# ALTEC SITE PLAN

## SITE PLAN AMENDMENT

### ALTEC INDUSTRIES SITE PLAN AMENDMENT

### 6th AVENUE IMPROVEMENTS PHASING

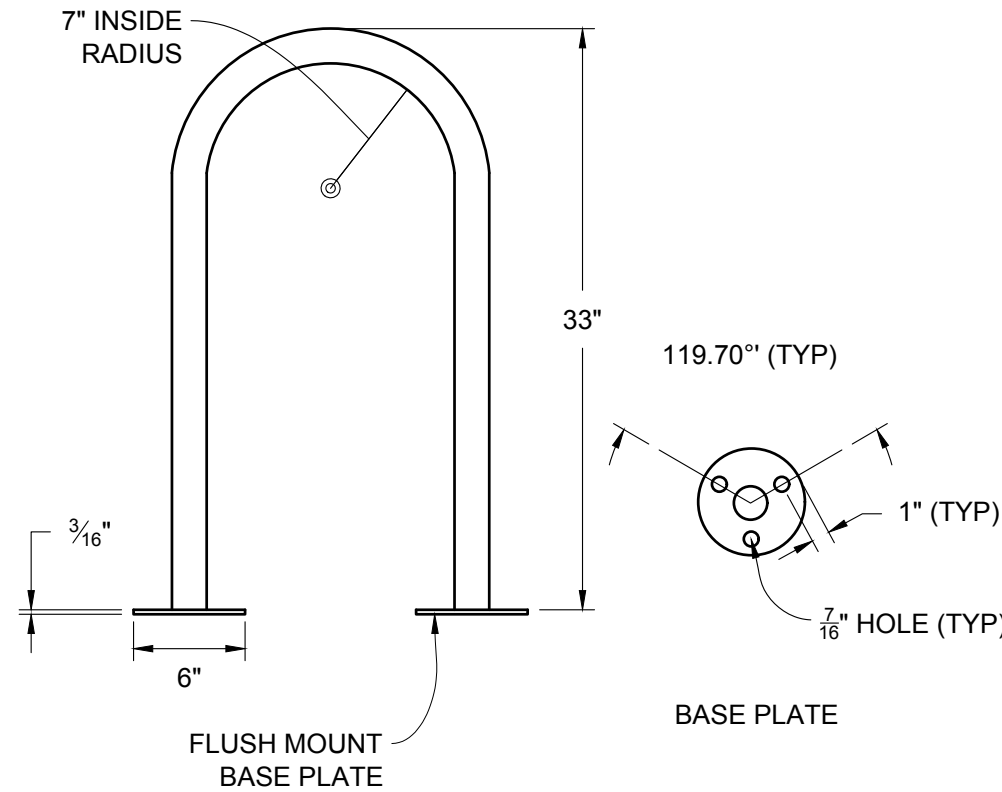
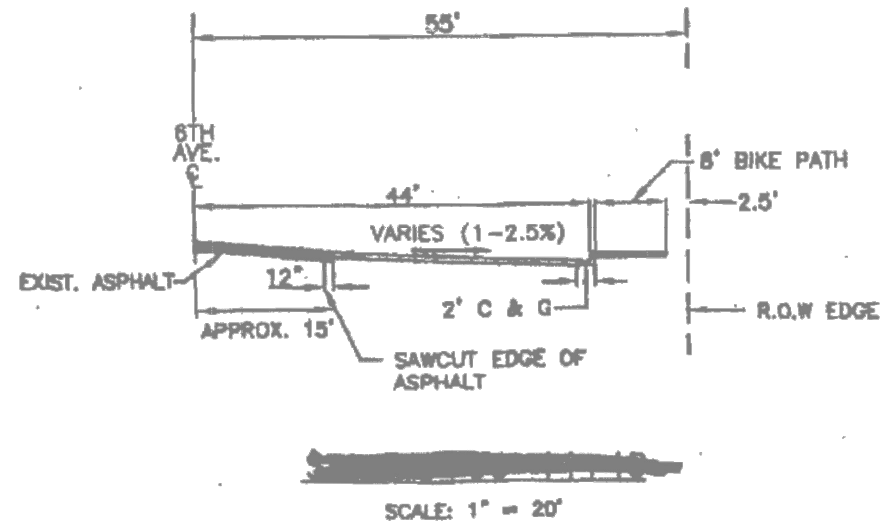
This has no context on this sheet.
